Title: Advisory Committee on Reactor Safeguards
Combined Thermal-Hydraulic Phenomena/
Future Plant Design Subcommittee Meeting
OPEN SESSION

Date: Friday, February 15, 2002

CHAIRMAN KRESS: This is a continuation of our Joint Subcommittees on Thermal-Hydraulic Phenomena and Future Reactor Designs, dealing with the subject of Phase 2 review of the AP1000 certification.

3-D Model Predicted Temperature Distribution

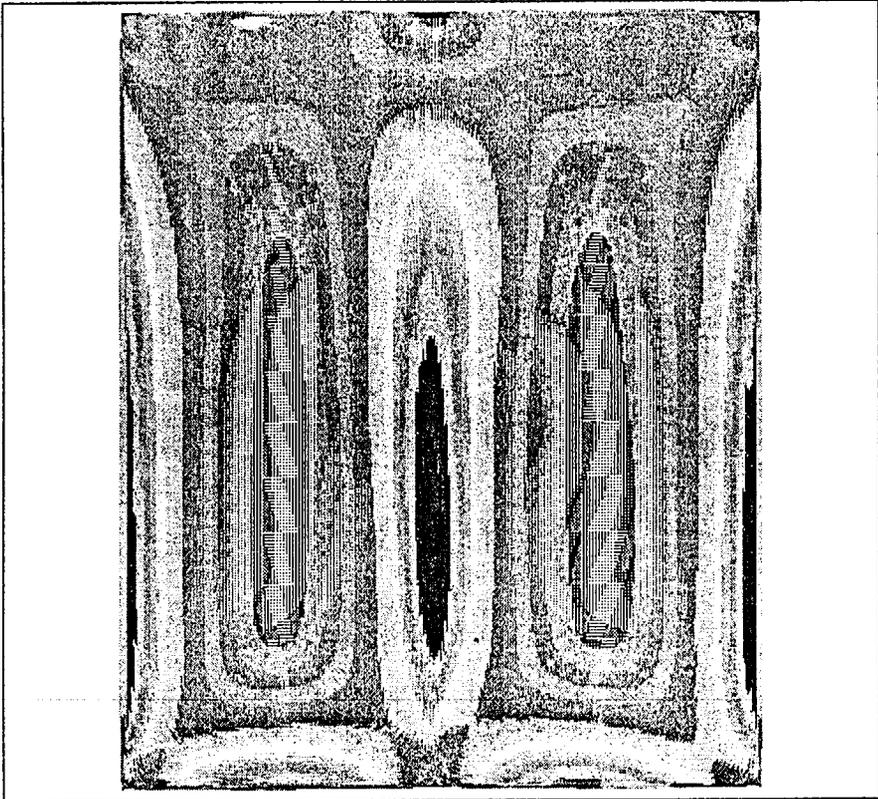
24 MEMBER WALLIS: So does this say it's well
25 mixed or does it show that it is a sort of circulating

18 MEMBER WALLIS: When you use k, it's
19 difficult to see the differences. I guess what I
20 would want to know is how much did that cold region,
21 the one affected region, change its temperature. You
22 can't tell just looking at it. That dark blue blob,
23 that elongated donut thing -- it doesn't mix very
24 much.

Void in Top of Core

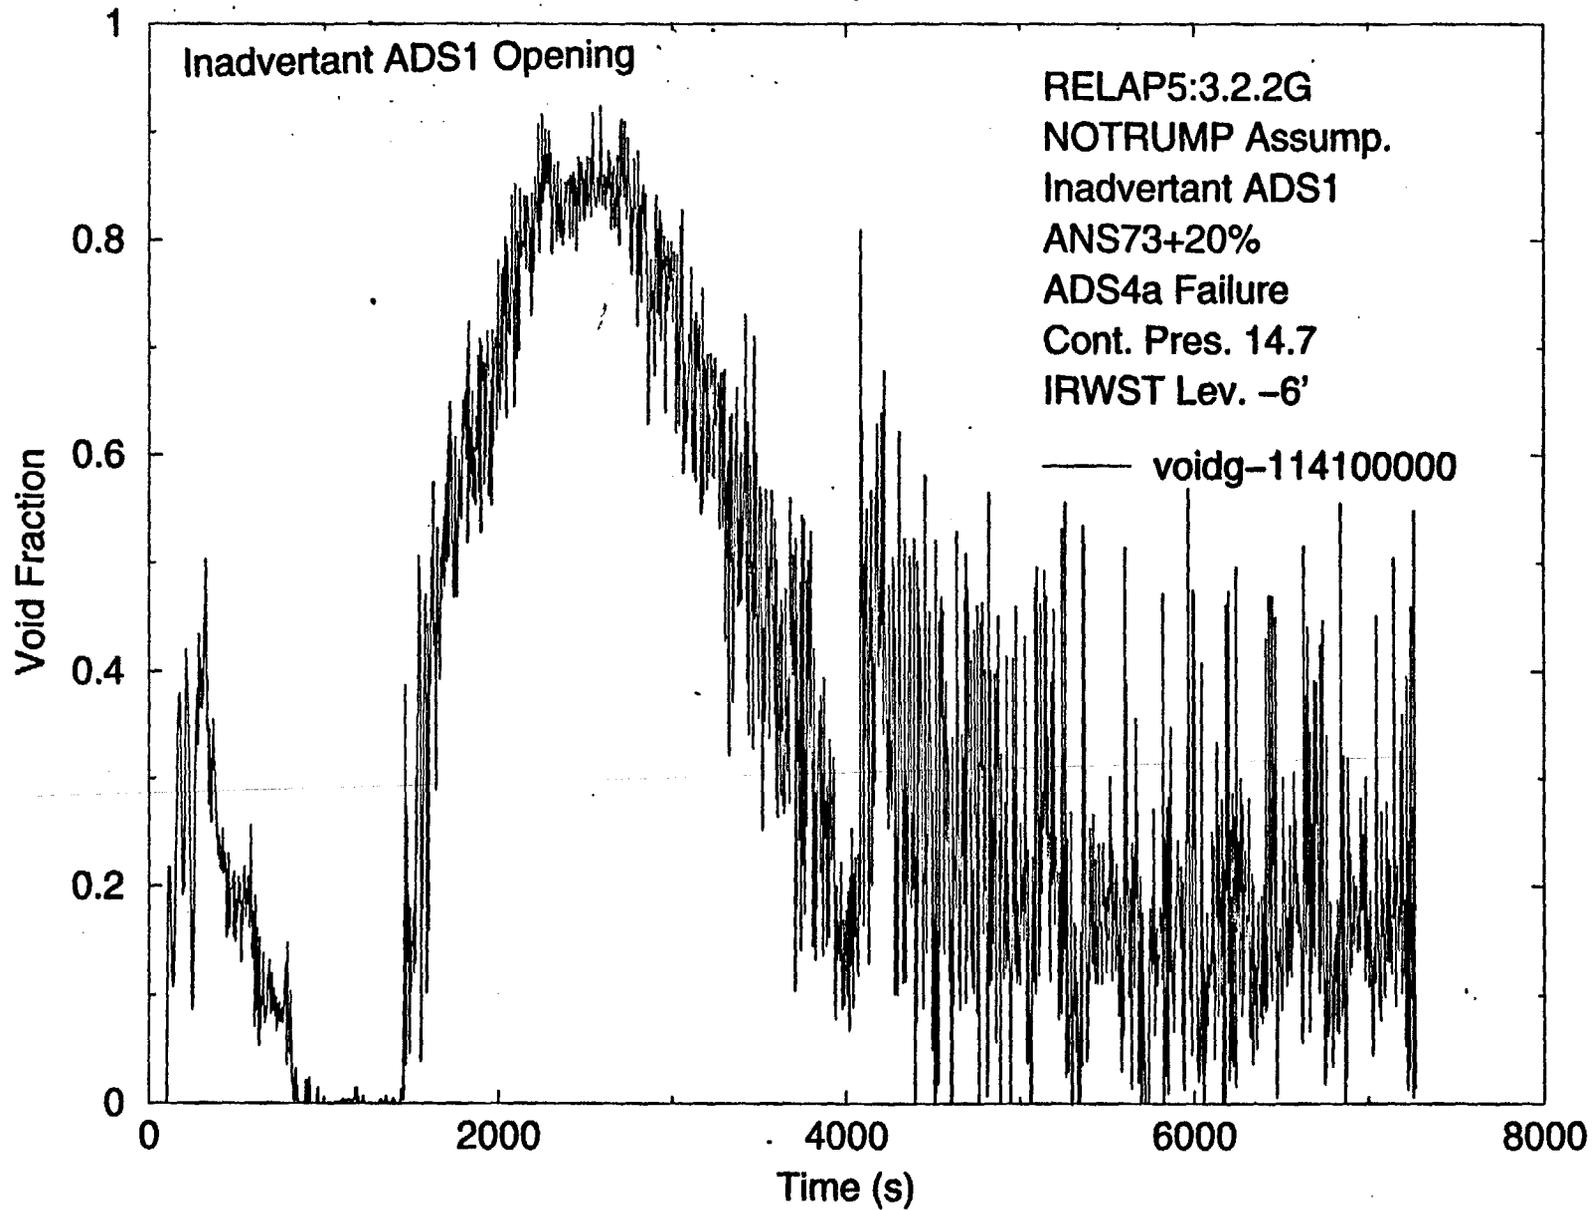
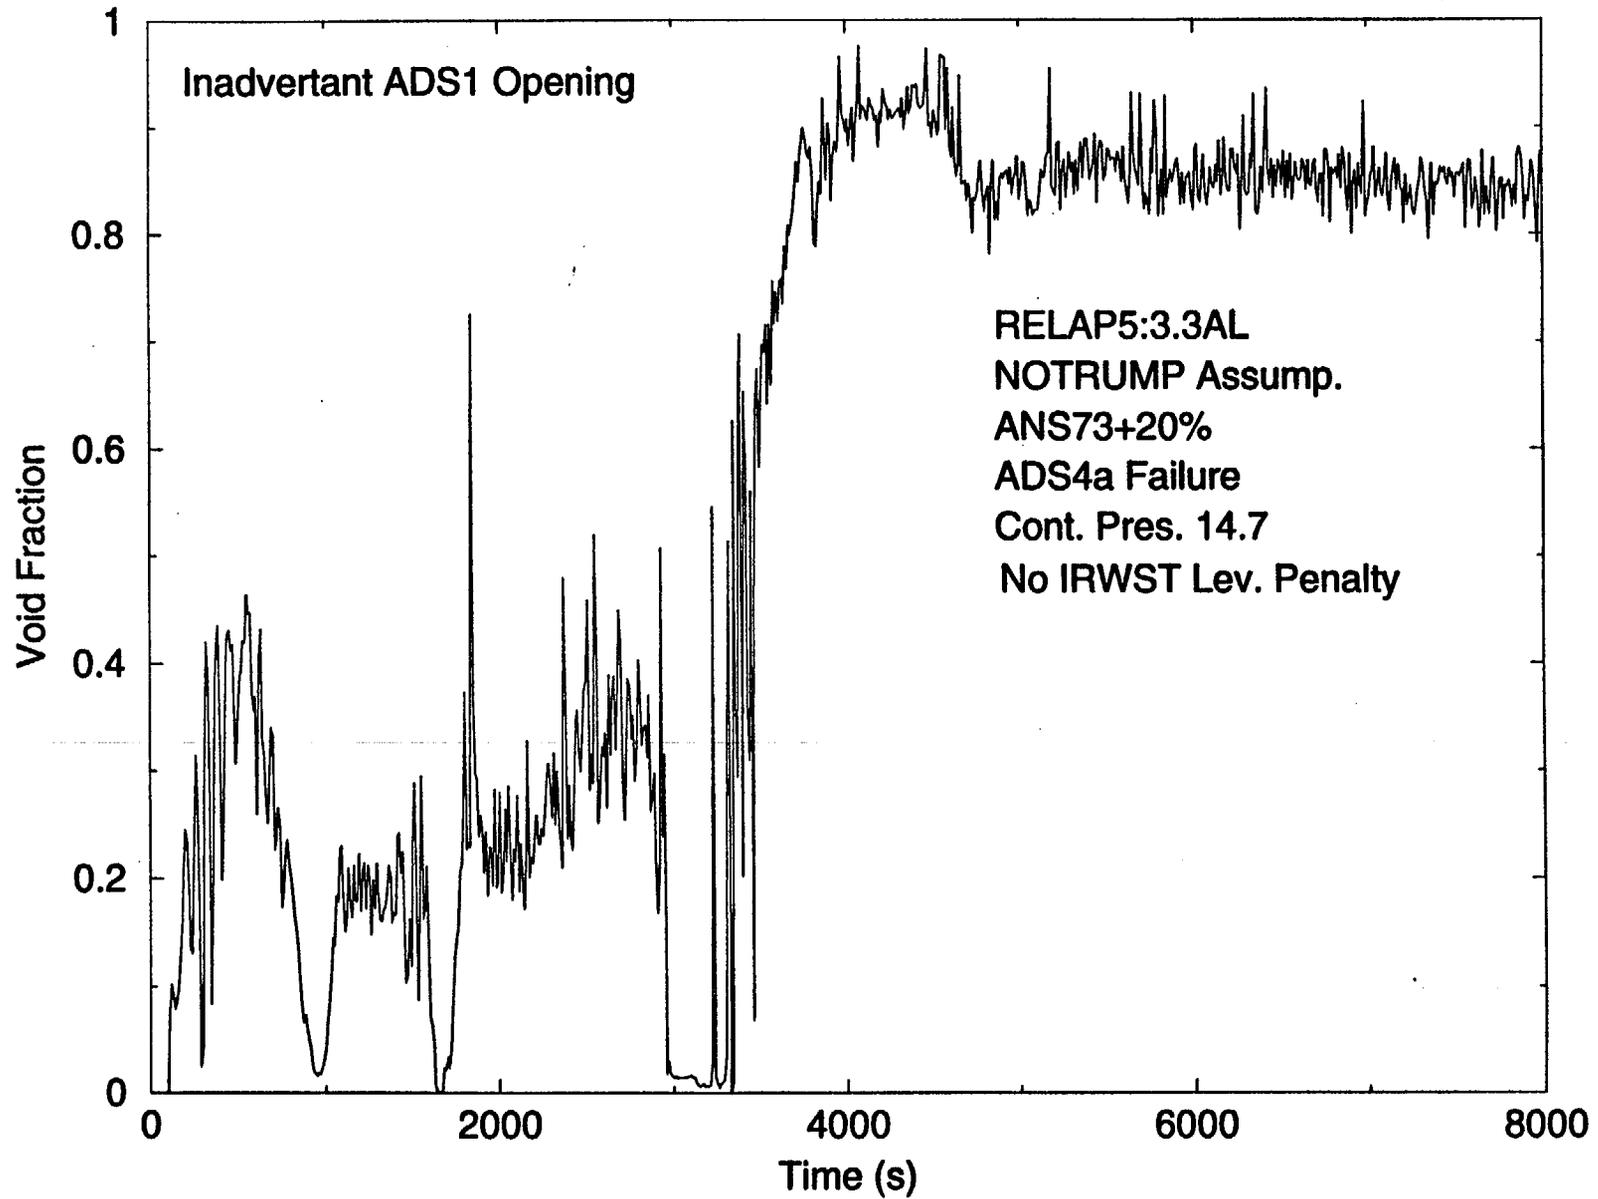
15 MR. JENSEN: Yes, sir. That's exactly
16 what I wanted to show you, that there's more voiding
17 than AP600, and the voids are higher, and they stay
18 there high a long time.

Break Flow Rate vs. Time

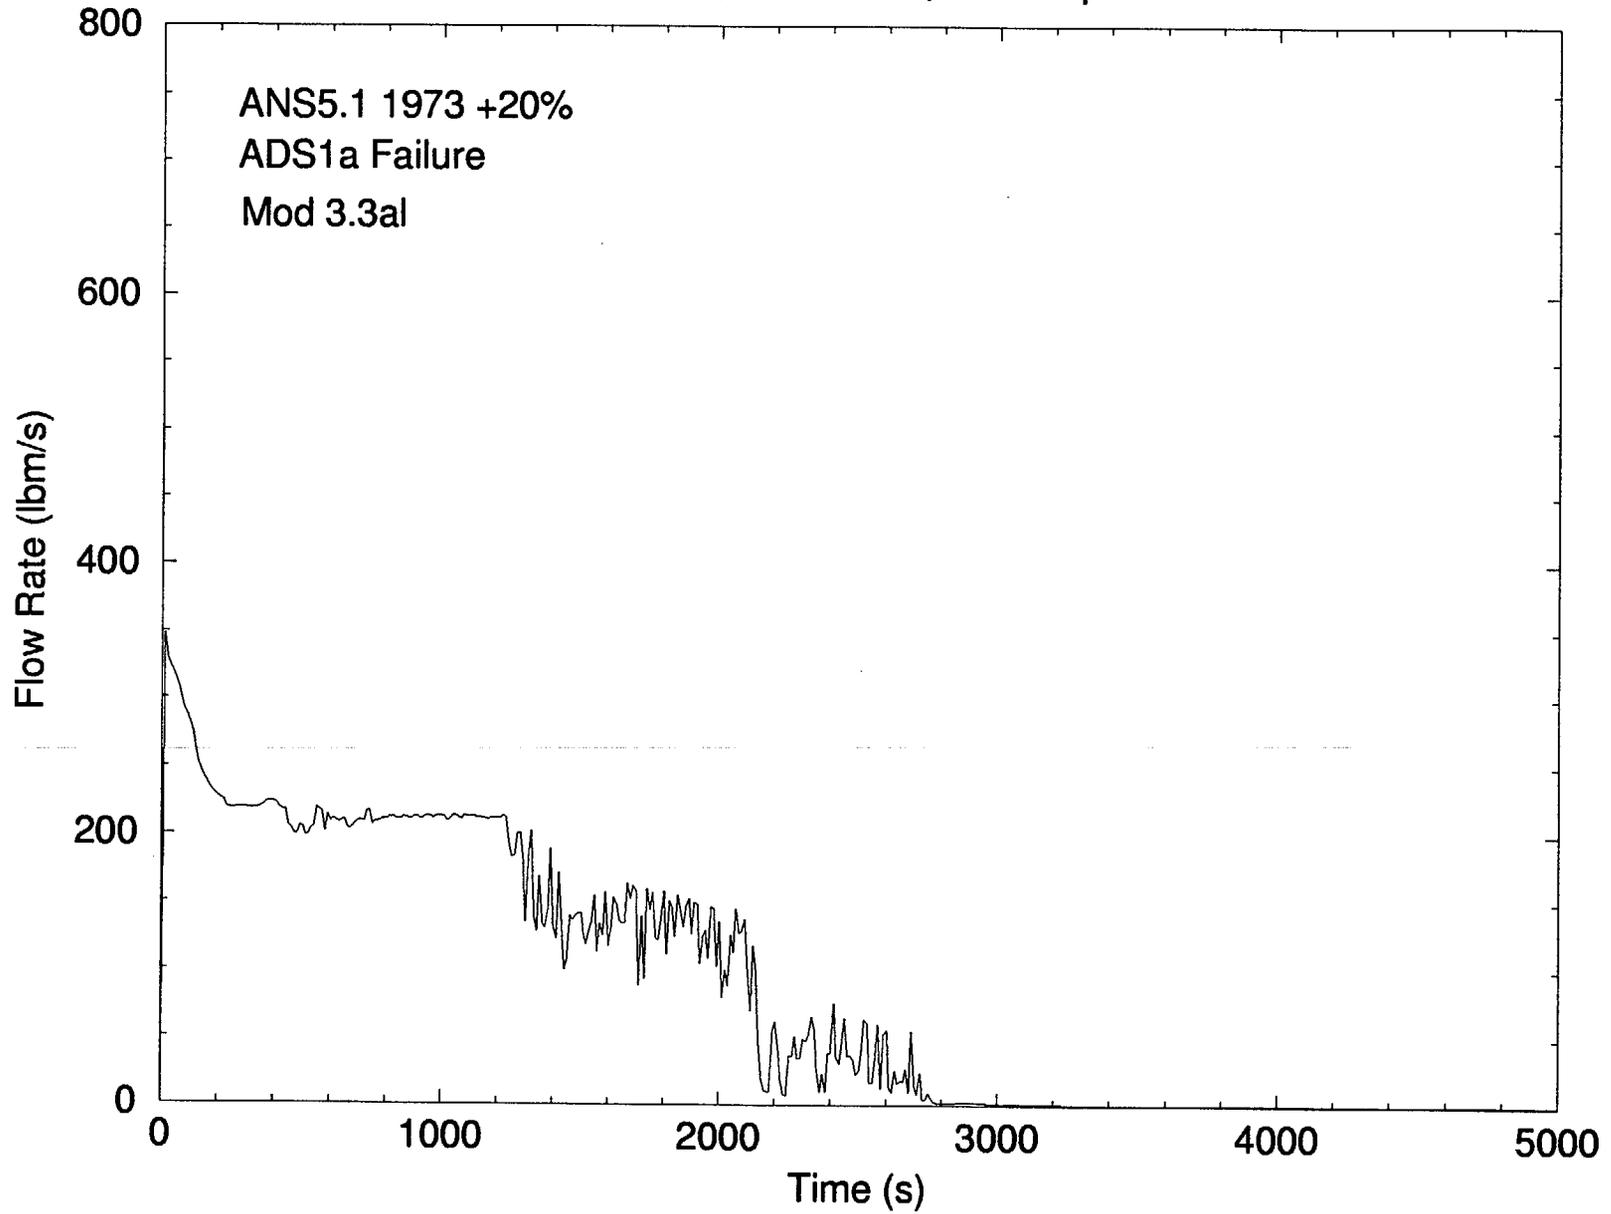
7 MR. JENSEN: This is RELAP. This is where
8 RELAP says the break flow is. I'm going to show you
9 the comparison in a minute, and I wished I had -- I
10 should have written RELAP on here.

AP600 vs. AP1000 2in49 Break Liquid Break Flow Rate

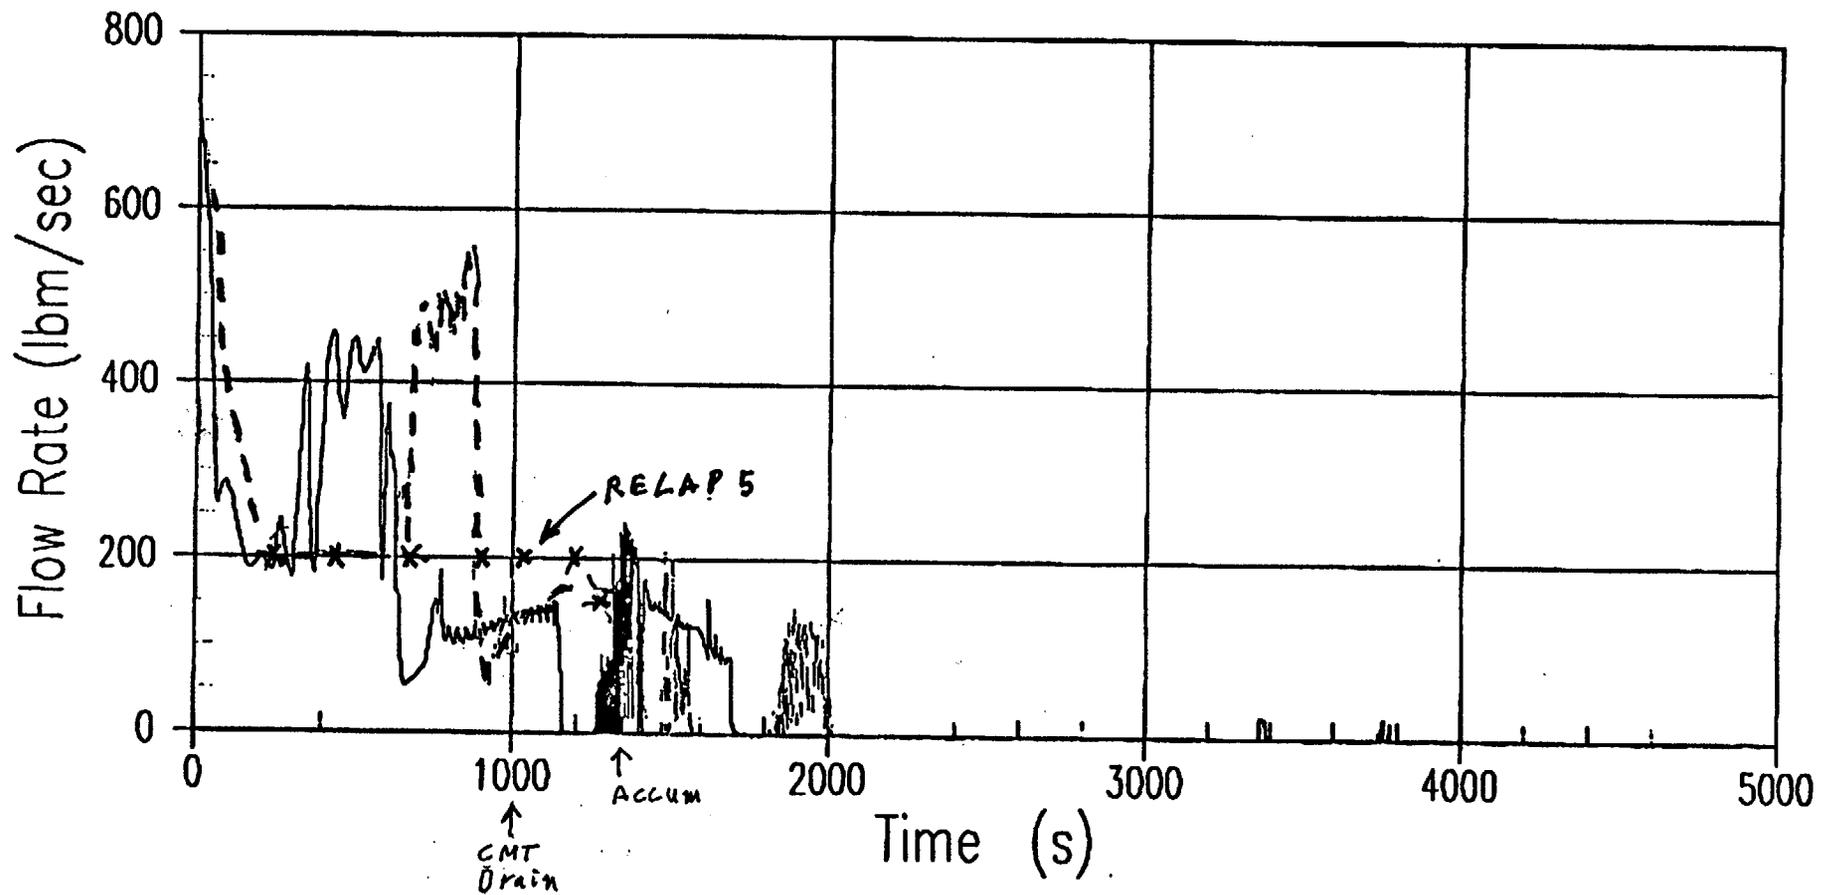
20 MR. JENSEN: I got a lot of things on
21 here. The solid line is AP600. It just happened to
22 be on this slide. I wish it wasn't. This is a
23 Westinghouse figure, but the dashed line is NOTRUMP
24 for AP1000. So that's what we want to look at, this
25 dashed line for AP1000. You see it?

20 MEMBER WALLIS: If I look at these two
21 curves, I'd say, well, AP600 and AP1000 don't have the
22 same response, do they?

13 MEMBER WALLIS: This is not very -- I
14 think the real thing is that, if you scaled the break,
15 you'll be able to show a much better comparison. That
16 would be more meaningful than maybe trying to wring
17 something out of this picture which is not very
18 meaningful.

20 Really, what we saw was really a time
21 shift for breaks of the same size. So that seemed to
22 be consistent with -- That led us again to a judgment
23 that the plants really do operate from a scale basis
24 the same.

PRHR Exit Flow Velocity

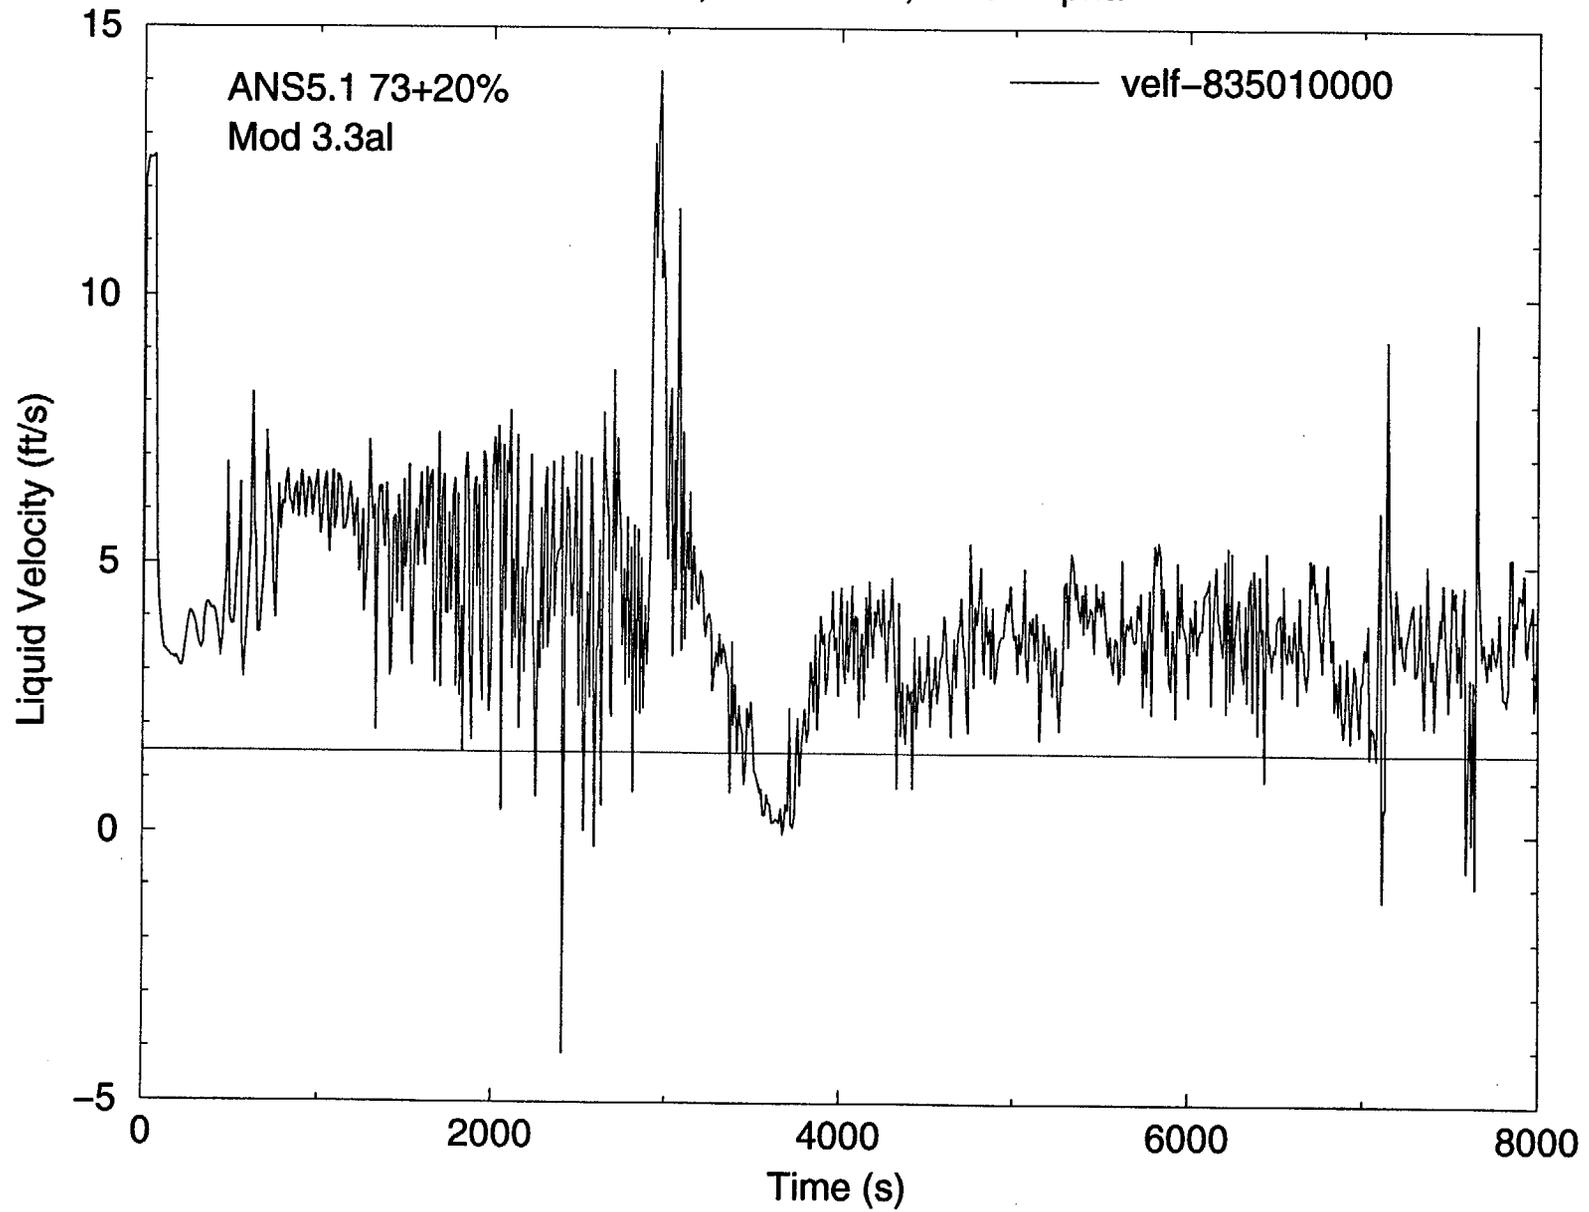
18 So then the question is what is the flow
19 rate in the PRHR heat exchanger tubes, and is it
20 greater or less than 1.5 feet per second? So this is
21 another RELAP calculation.
